**SAFETY ADVISORY # 14-218****Rubicon Generator Fuel Line Clamp**

**Model and Serial Numbers Included:**

2015 Rubicon Travel Trailers

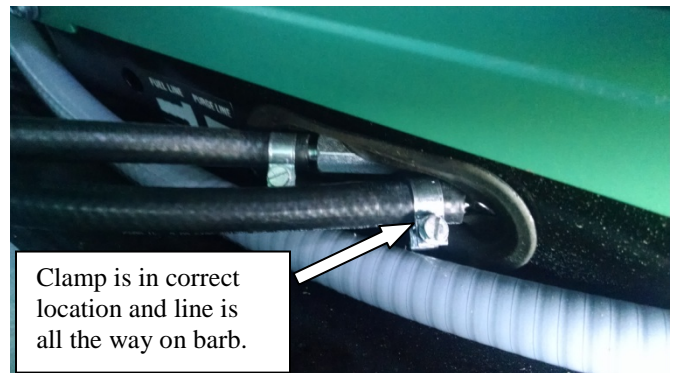
Keystone RV Company is conducting a voluntary RECALL notification campaign in accordance with the National Traffic and Motor Vehicle Safety Act. It has been decided the vehicles subject to this recall campaign may not have the clamp installed correctly at the generator fuel filter and fuel tank. If the fuel line becomes disconnected it increases the risk of a fuel leak leading to an increased risk of fire, personal injury and property damage. This advisory explains how to correct the problem.

**Parts Required per Unit:** None**Tools Required:** Slotted Screwdriver**ONE      INSPECTION and REPAIR****Step 1**      Locate the trailer on a level, flat and hard surface. Chock the wheels.**Step 2**      Look under the generator and inspect the incoming fuel line and clamp to the generator where the line attaches to the fuel filter. Verify the fuel line is fully engaged on the barb fitting and the clamp is in the proper position and it is tight. See Figure 1 & 2.**Figure 1 - Incorrect****Figure 2 – Correct****Step 3**      Look at the fuel pickup line on the fuel tank. Verify the fuel line is fully engaged on the barb fitting and the clamp is in the proper position and it is tight. See Figure 3 & 4.
